SI B51 24 17  
Body Equipment

## RECALL 17V-328: E65/E66 (7 SERIES) DOOR LATCHES

This Service Information bulletin supersedes SI B51 24 17 dated **January 2018**

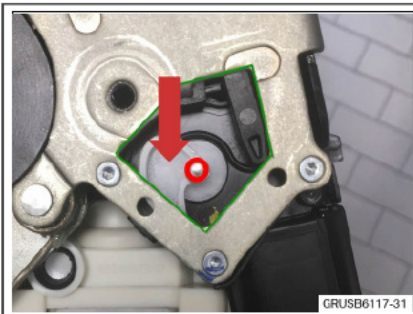
- Once the door lock is removed, modify each lock by removing the white or yellow opening assist cam (red arrow).
- UPDATE!** If the door lock is replaced modify the new door lock as outlined below

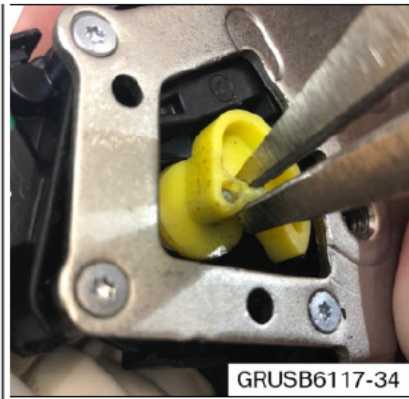
- Manually position the cam so that it is clearly visible in the opening.

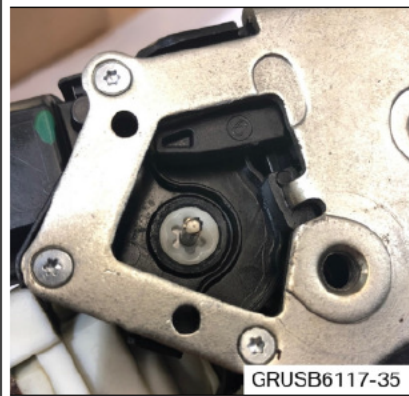
- Cut the head of the cam retainer off with a pair of cutters.
